U.S. Department
Of Transportation
**Federal Highway
Administration**

Refer to: HNG-14/SS-59A

Supplement to Geometric and Safety Design Acceptance Letter SS-59

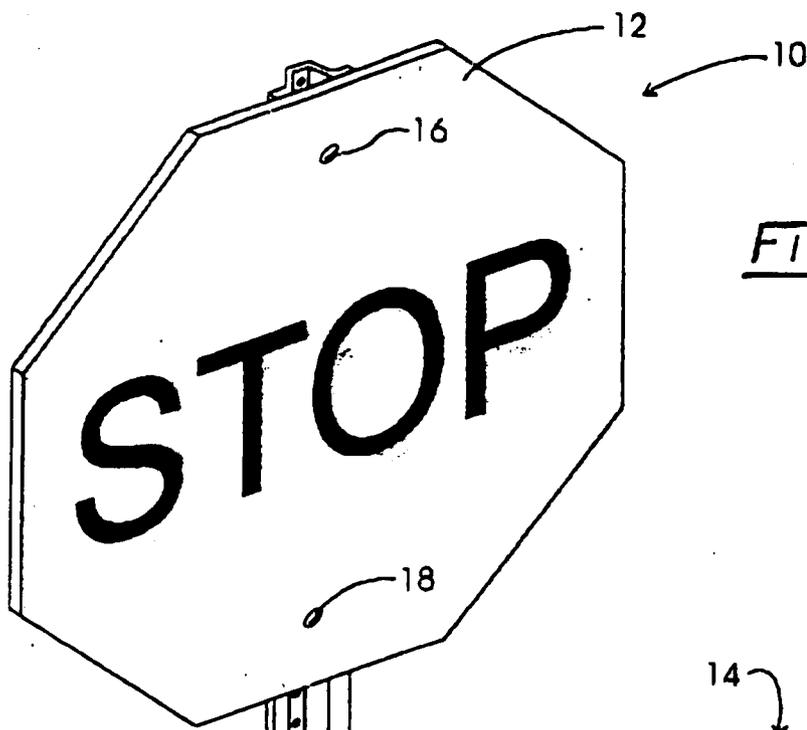
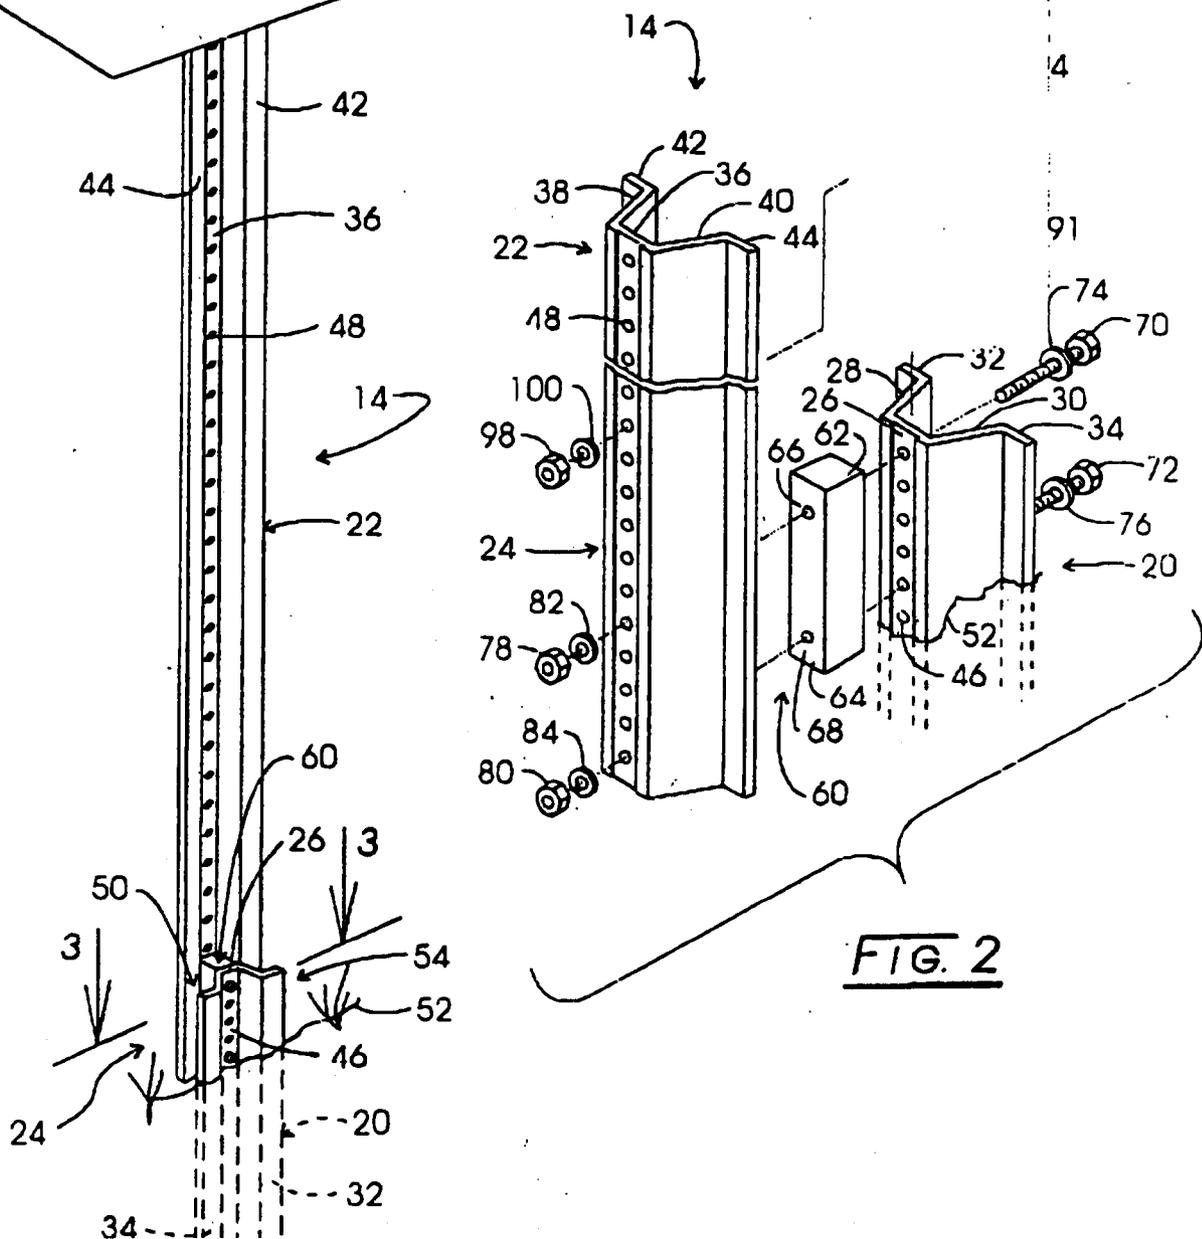
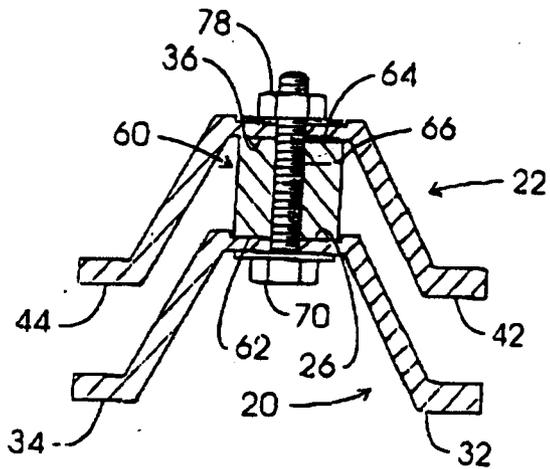
The proposed modification would replace the un-threaded spacers used with each of the two connecting bolts with a single bar of steel, drilled and tapped with threaded holes 4 inches (102 mm) apart. The spacer bar will be 3/8-inch (9.5 mm) thick, as were the individual spacers used in the crash tests. A Drawing of the Safety Splice with the bar spacer is enclosed.

We concur that the spacer bar will cause no significant change to the breakaway performance of the Safety Splice system and that no additional crash testing will be required. Therefore, your company's breakaway Safety Splice system with the spacer bar will be acceptable for use on the Nation Highway System when requested by a Sate. All other conditions in our March 7 letter remain in effect.
